Subject: Old Town Escape Barn Assessment Letter; Project No. 658052,  
Internal Order No. 24008534, Old Town

The Development Services Department has completed the Second review of the project referenced above, and described as:

Planned Development Permit and Conditional Use Permit for an escape room with two residences, located at 3886 Ampudia St. The 0.11-acre site is in the OTMCR-1-2 Zone, within the Old Town San Diego Community Plan area.

SHEET 7 of 11

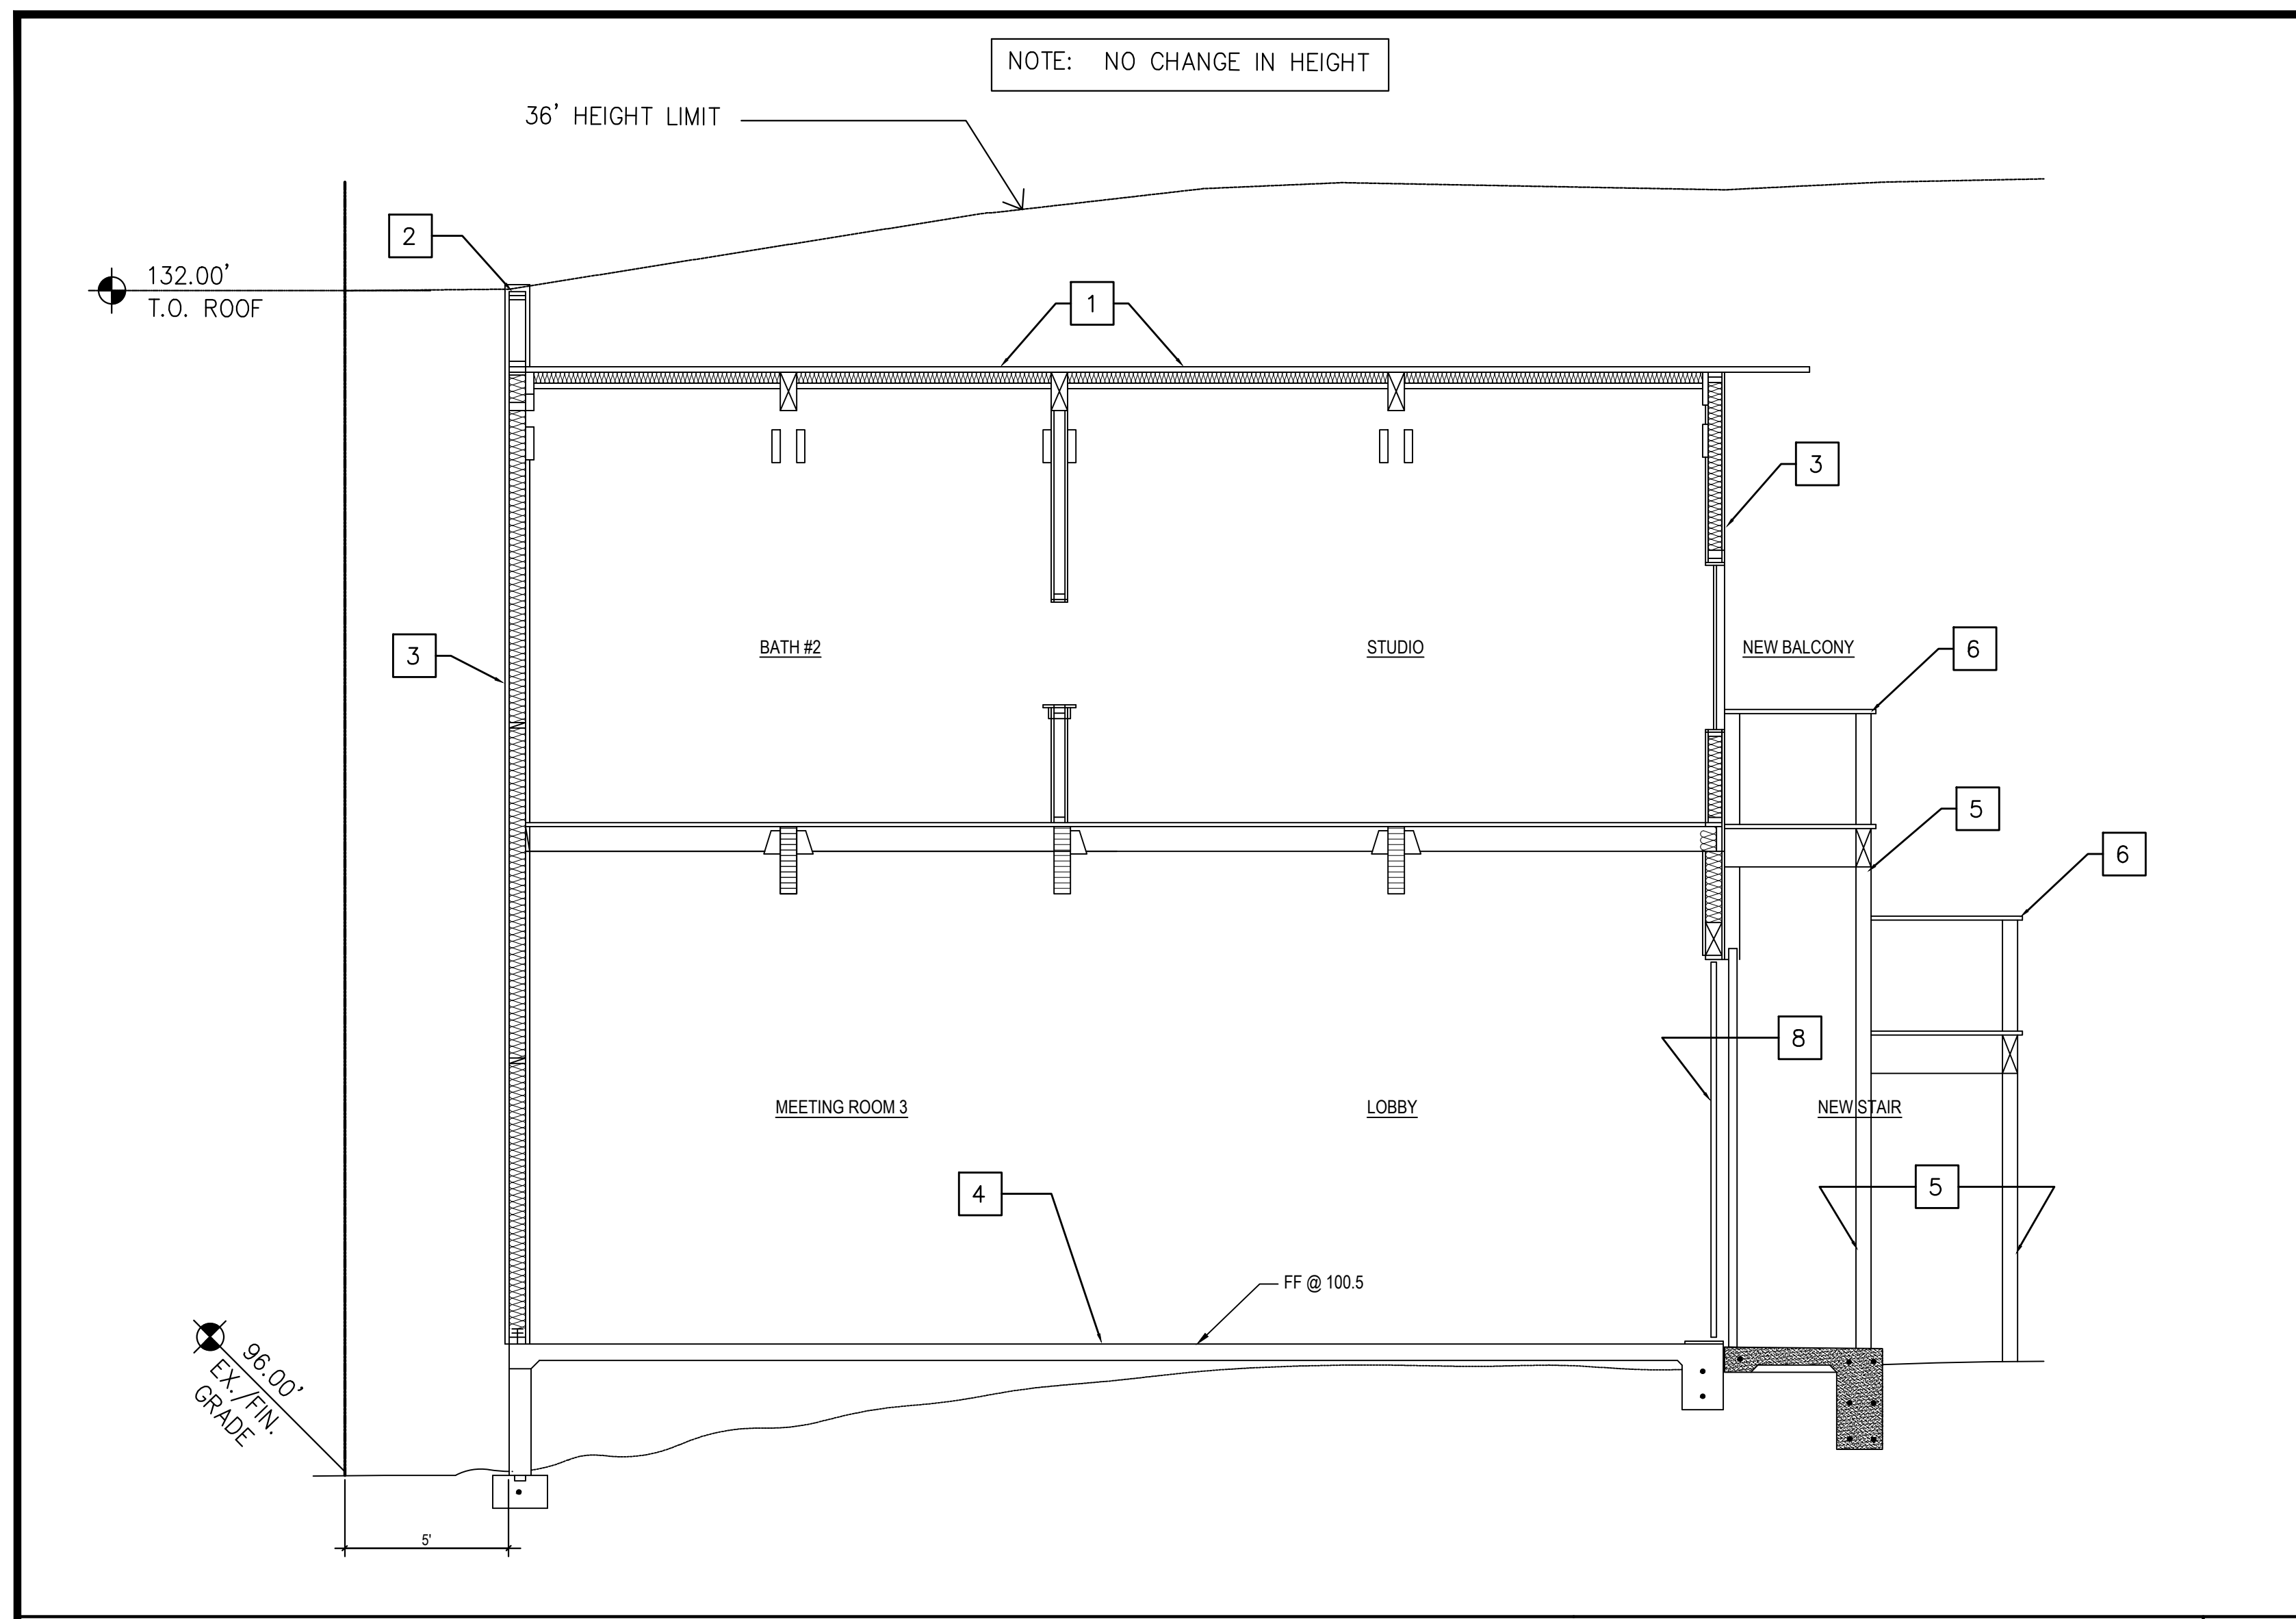
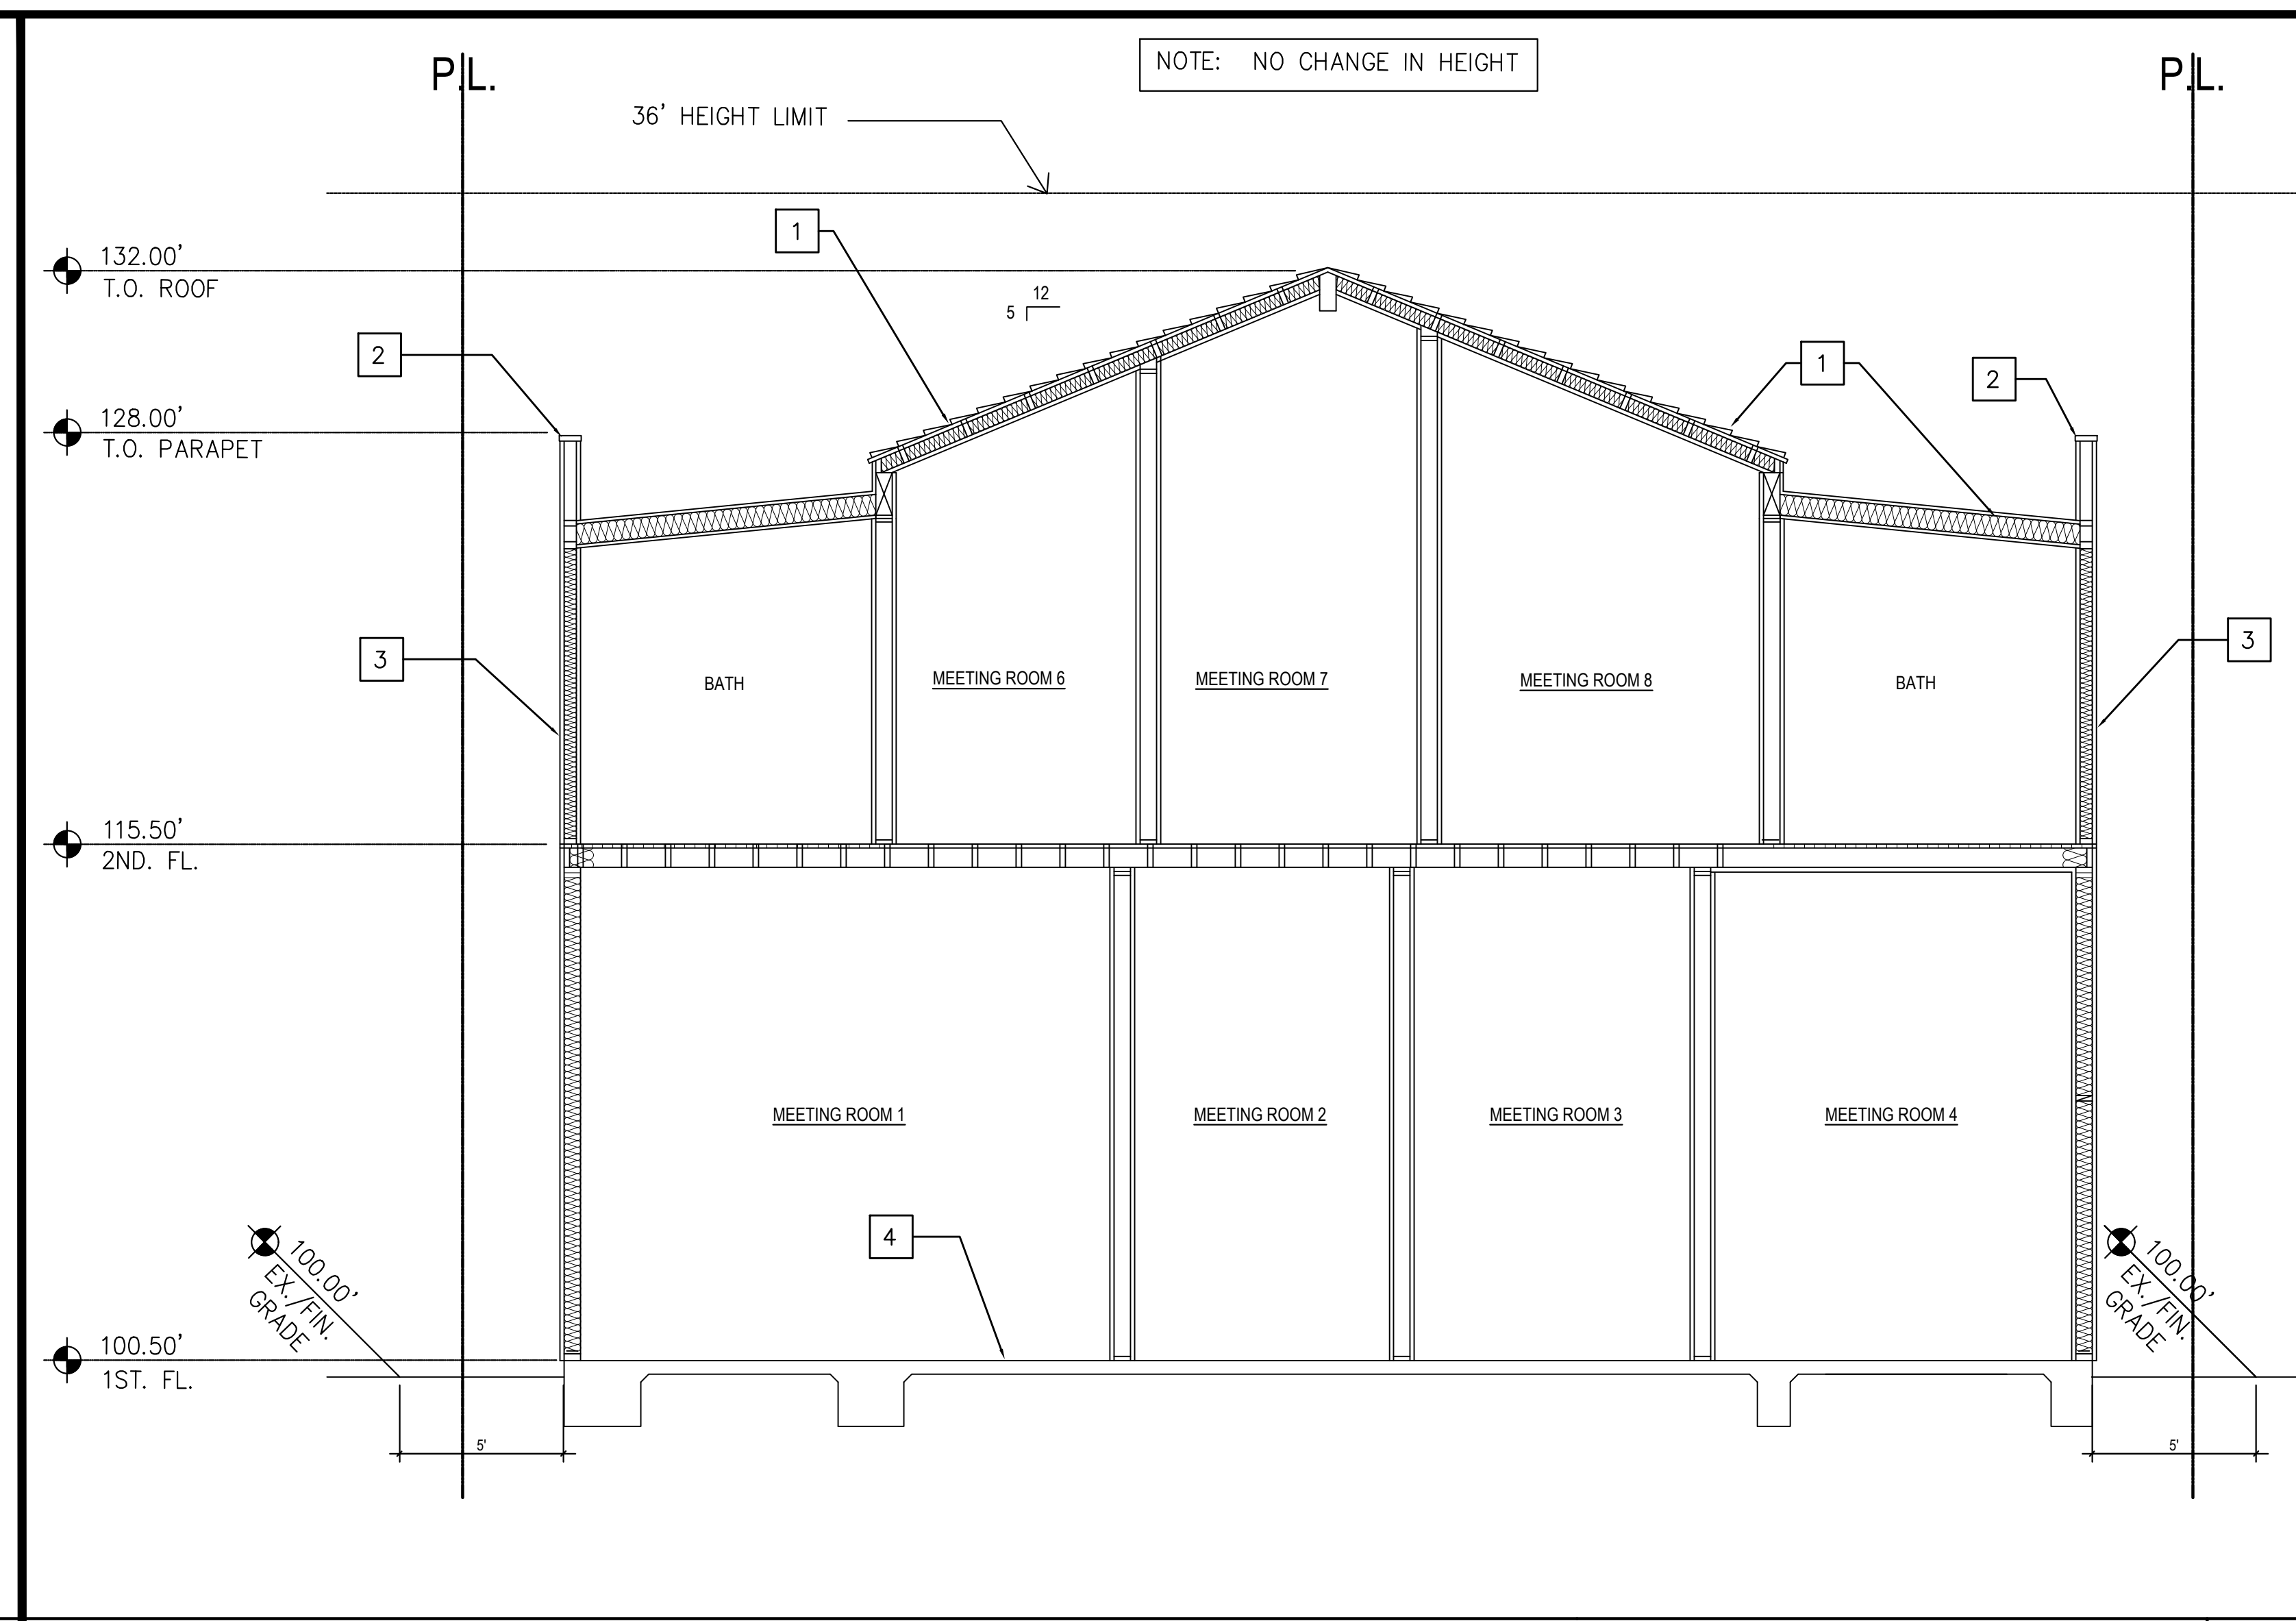
<u>Cleared?</u>	<u>Issue Num</u>	<u>Issue Text</u>
<input type="checkbox"/>	10	Please correct the Keynotes 9 and 10 on sheets 6 and 7; they are mislabeled. Keynote 9 states that the existing window to remain, but it is labeled on a door and Keynote 10 states existing door to remain, and it is labeled on a window. (From Cycle 2)
<input type="checkbox"/>	11	Please correct the sheet number within the note on Sheet 1 that states "Demolish and Reconstruct Parking Lot. See Sheet 9 for conceptual Landscape Plan". The Landscape Plan is on Sheet 11 (not Sheet 9) - the note needs to be corrected to reflect this change. (From Cycle 2)
